Memo to: El Paso County PCD

From: Core Engineering Group

RE: Jimmy Camp Creek Main Channel Lorson Blvd Bridge (CDR -17-7)- Review1
Response to Comments

FINAL GRADING/EROSION CONTROL PLAN

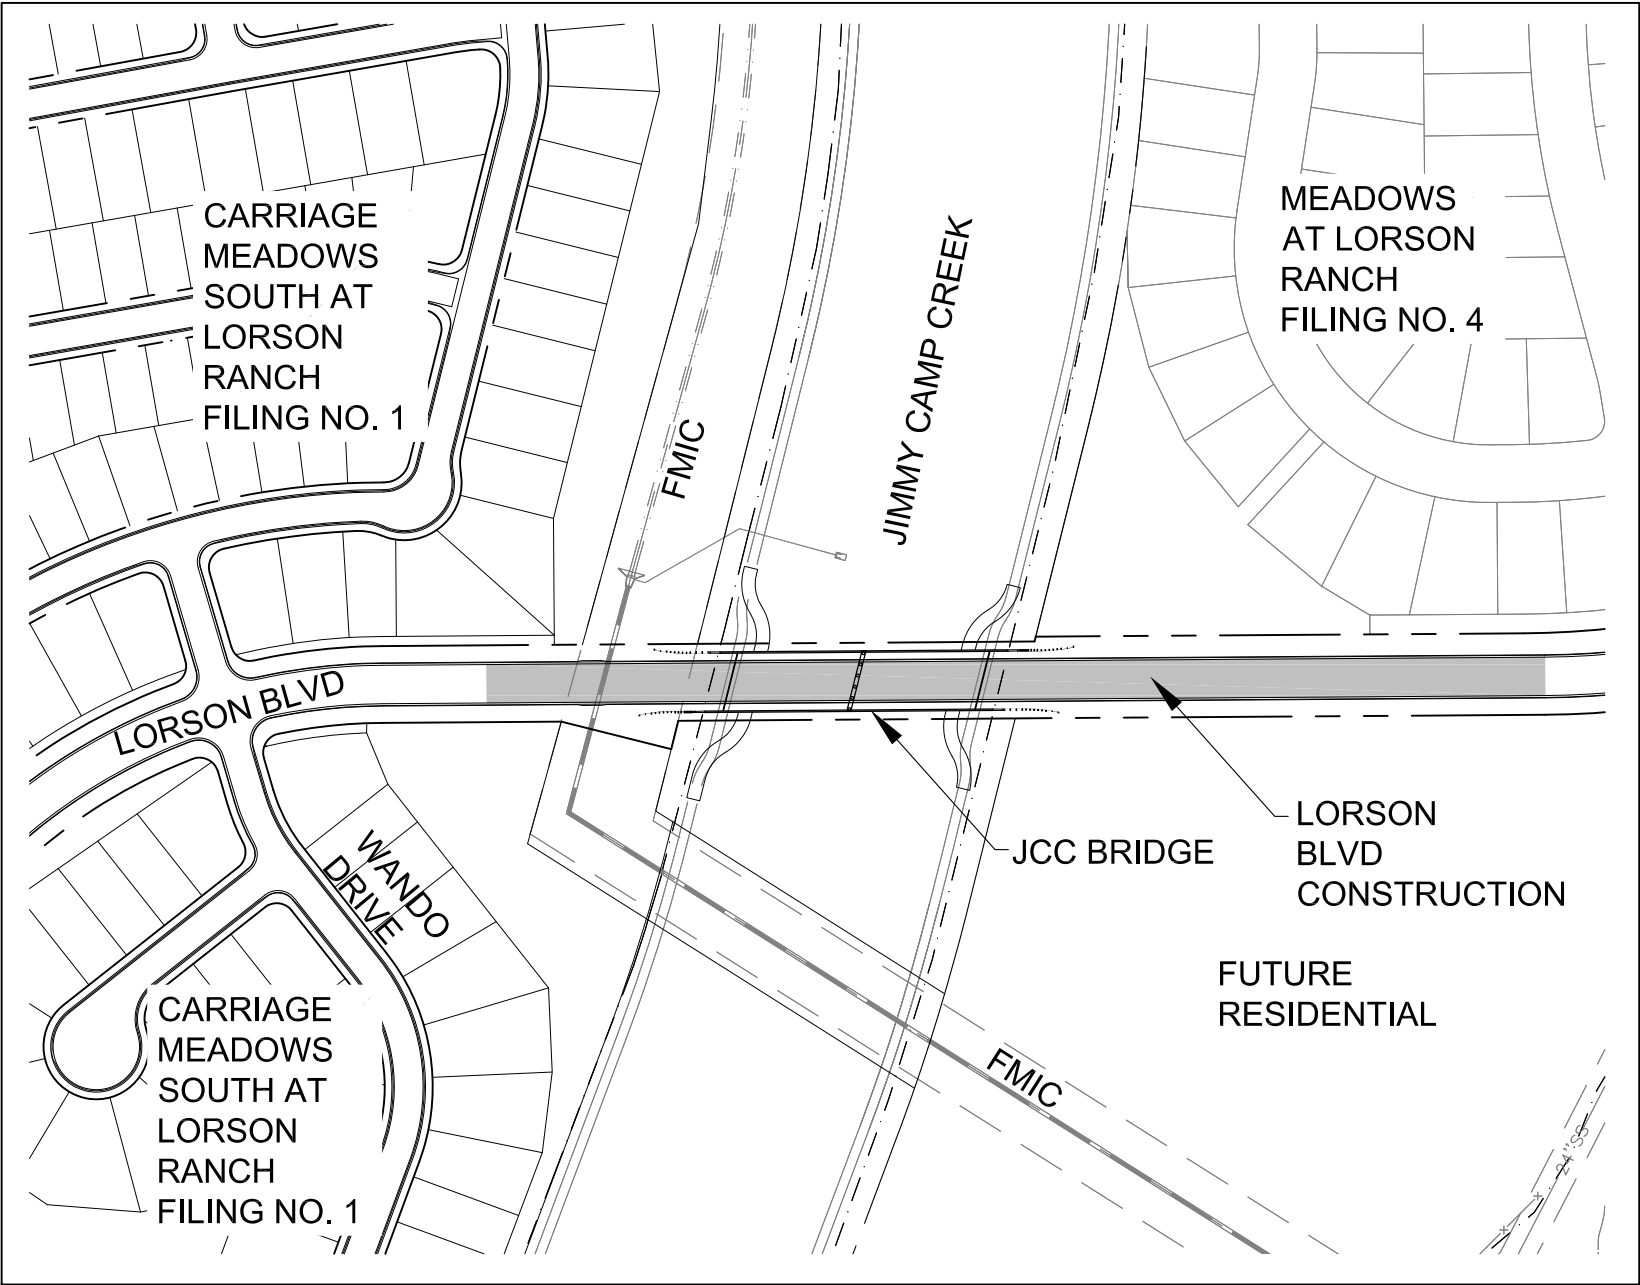
Use standard GEC Plan signature blocks.

Use standard GEC Plan signature blocks.

Provide actual cross-section across creek

Provide flow arrows

Provide Temporary Sediment Basin

Provide Temporary Sediment Basin
